**MINUTES OF THE PLANNING AUTHORITY MEETING
OF THE BRIGHTON COUNCIL, HELD IN THE COUNCIL CHAMBERS,
COUNCIL OFFICES, 1 TIVOLI ROAD, OLD BEACH
AT 6.05P.M. ON TUESDAY, 6 MAY 2025**

5.1 Development Application DA 2025/00037 - Seasonal Employee Accommodation, 647 Baskerville Road, Old Beach

Figure 5: Waterway and Coastal Protection Overlay (Source: PDA report, 25/1/24, p4)

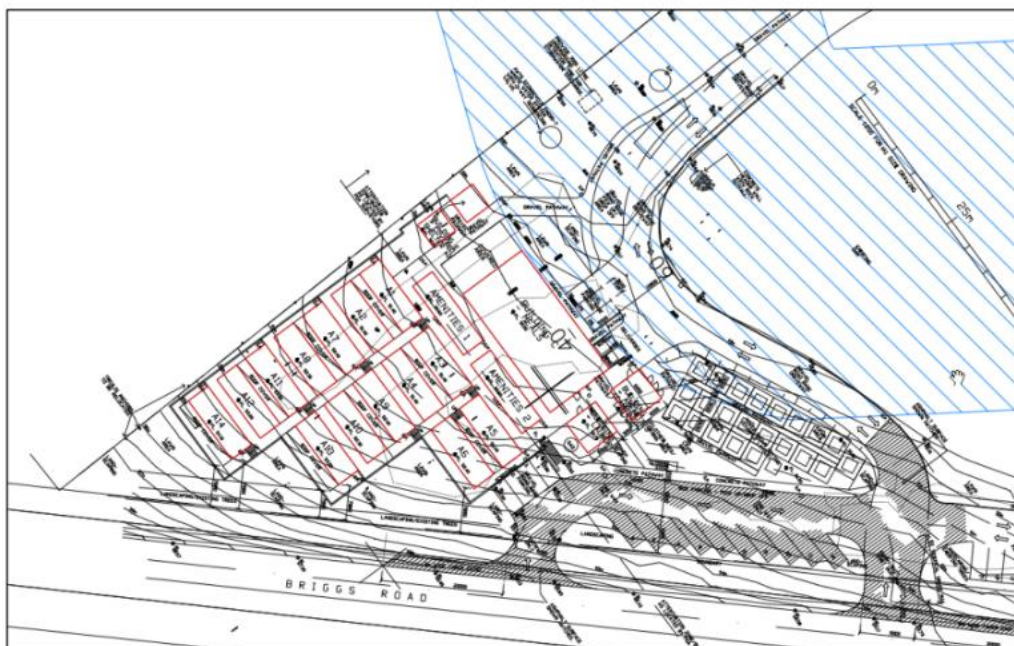
The proposal includes some works within the Waterway and Coastal Protection Code (Figure 5).

The works within the overlay include internal road works, some parking and a small corner of the proposed campsite located within the overlay area.

The applicant's proposal documents demonstrate that parking areas and the campsite will be outside the 1% AEP, as are the proposed buildings.

The vulnerable use relates to the site being used for visitor accommodation. As can be seen from Figure 5, a small amount of camping spaces are within the waterway and coastal protection area. However, as outlined in the PDA report, the residential areas which form the visitor accommodation component of the site are located outside the 1% AEP, with all buildings, camping site, main access and parking area limited to a H1 flood risk zone. The gravel driveway and pathway are exposed to H2 and H3 flood risk zones, but can be safely avoided in flood events by utilizing the main access from Briggs Road. Accordingly, it is considered that the risk for the visitor accommodation use is low and can be protected from flood.

Accordingly, it is unlikely that the development will have any adverse impact on the natural values. It is considered that any site works can be managed through a soil and water management plan to be approved by Council's Municipal Engineer prior to commencement of works.

A condition is recommended that an Emergency Management Plan be provided to Council, prior to commencement of use which specifies the procedures to be undertaken by the land owner in case of emergencies and extreme events.

Figure 6. Cross-section through development showing buildings and 1% AEP flood level (PDA Stormwater Report – Revision 3, dated 25 Jan 2024).

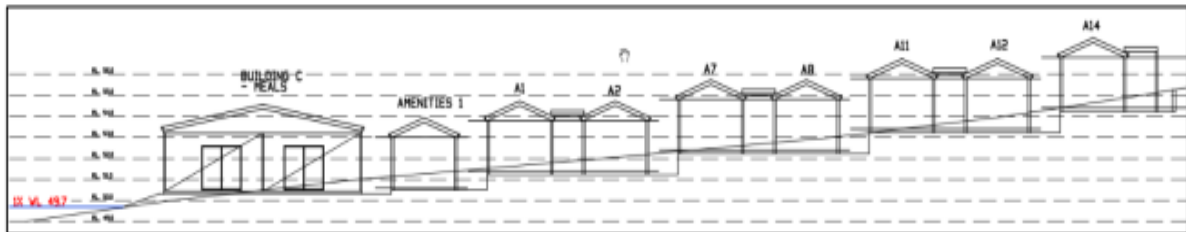
The applicant has submitted a report which demonstrates that the proposal can comply with P1.1. by achieving and maintaining a tolerable risk from flooding, and takes into account a RCP 8.5 climate change scenario. All buildings are situated above the 1% AEP flood levels, as are the camping and parking areas.
